LOCUST GATEWAY DEVELOPMENT PROJECT

Final Environmental Impact Report

1.0 SUMMARY OF THE FINAL ENVIRONMENTAL IMPACT REPORT

Exhibit 3: Land Use Plan within the Rialto Airport Specific Plan also depicts Summit Avenue bisecting the project site.

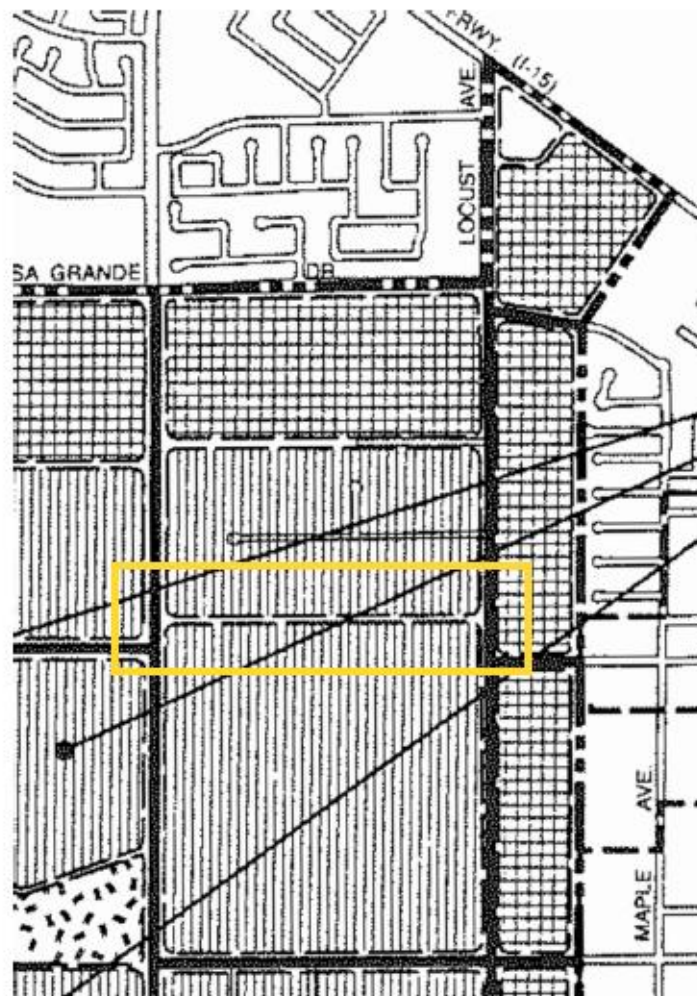
The EIR states that, "The Project's circulation plan would be consistent with the General Plan pertaining to transit, bicycle and pedestrian facilities." The EIR does not analyze the project in accordance with the City's Circulation Map. Exhibit 4.1 – Street Classifications within Circulation Element²¹ depicts Summit Avenue bisecting the project site through to Locust Avenue. The dashed purple lines on Exhibit 4.1 indicate that Summit Avenue is a planned Collector Street within the project site.

The Project conflicts with Exhibit 4.1 - Street Classifications within the Circulation Element and Exhibit 3: Land Use Plan within the Rialto Airport Specific Plan, which are plans and policies addressing the circulation system. A General Plan Amendment is required to remove the planned extension of Summit Avenue through the project site from Exhibit 4.1 - Street Classifications within the Circulation Element. A Specific Plan Amendment is required to remove the planned extension of Summit Avenue through the project site from Exhibit 3: Land Use Plan within the Rialto Airport Specific Plan. The project has not applied for these entitlements and the EIR does not address the planned extension of Summit Avenue. The project conflicts with these plans and policies addressing the circulation system, and therefore a finding of significance is required as part of a revised EIR.

The City's Engineering and Planning staff have confirmed that no capital improvement, right-of-way acquisition, or entitlement actions are planned or funded to construct this segment of Summit Avenue. The Rialto Focused General Plan Update retained the conceptual depiction of Summit Avenue on Exhibit 4.1 as a legacy element from earlier plans; however, the planned roadway segment is not an actionable or implementable improvement and has been superseded by subsequent development patterns and circulation system modifications.

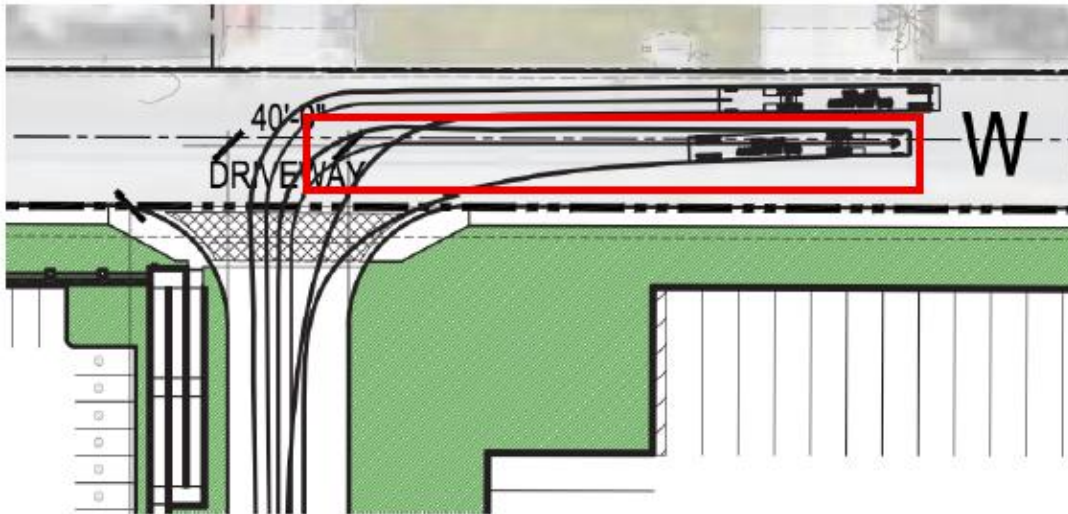
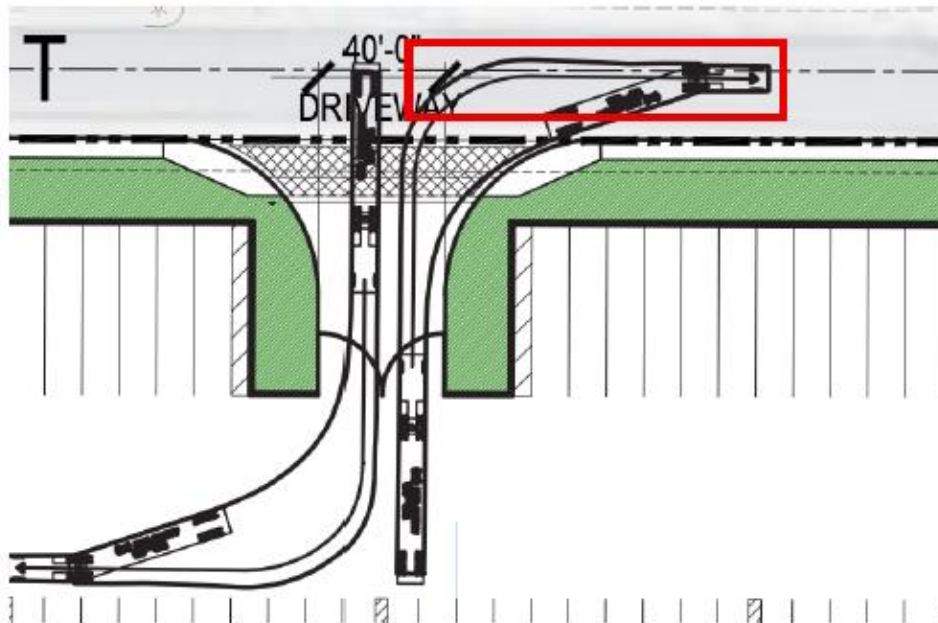
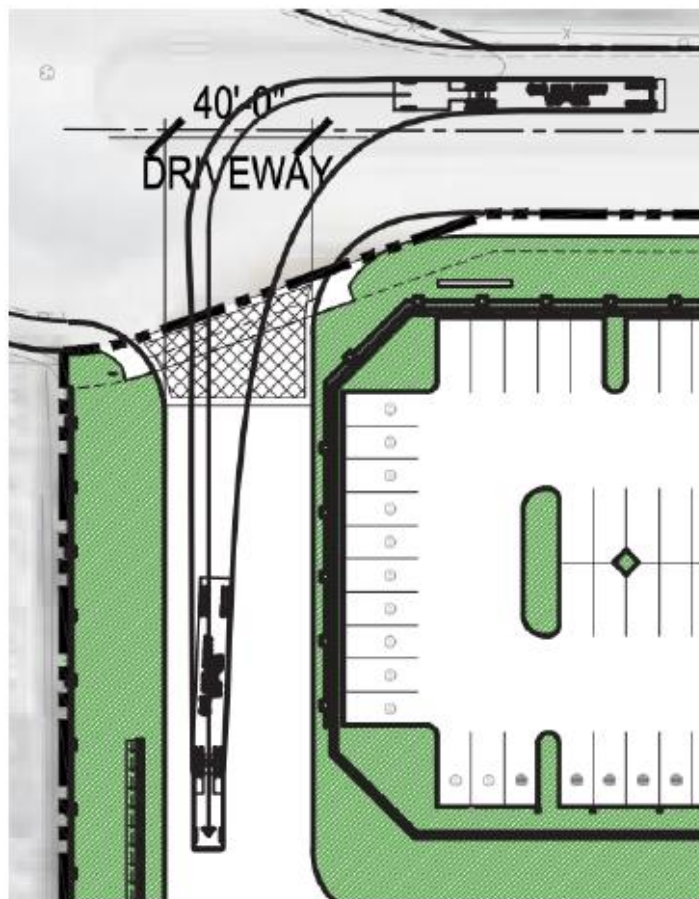
Figure 3-5: Conceptual Truck Circulation Plan depicts several areas of conflict between vehicles. For example, trucks are modeled exiting the site via the central and eastern driveways on Lowell Street. They require additional maneuvering space across the centerline of each street, meaning that the trucks will need to drive on the "wrong side" of the street into oncoming traffic in order to leave the site.

Additionally, the overlapping lines along the internal driveway indicate that it is not wide enough to accommodate more than one truck/trailer. Queuing/storage space is required on Lowell Street and the EIR has not analyzed these significant impacts. A finding of significance is required in a revised EIR.

Further, the truck/trailer entering the site via the easterly driveway on Lowell Street is not modeled to execute the full turning maneuver. The modeling must be updated to depict the truck/trailer entering the site conducting a full turning maneuver in order to provide an adequate and accurate environmental analysis.

The truck/trailer modeling at the westerly driveway on Lowell Street and the driveway on Locust Avenue only depicts trucks/trailers entering the site. It does not model trucks/trailers simultaneously exiting and entering the site at these access points, meaning that there is not enough space to accommodate full truck maneuvering. The modeling must be updated to depict trucks/trailers simultaneously exiting and entering the site.

It is also not possible to discern the size of the truck/trailer utilized for modeling throughout Figure 3-5. The EIR must be revised to model a WB-67 truck (a standard 72 feet in length) maneuvering throughout the site and accessing the site at all vehicular access points in order to provide an adequate, accurate environmental analysis and worst-case scenario modeling.
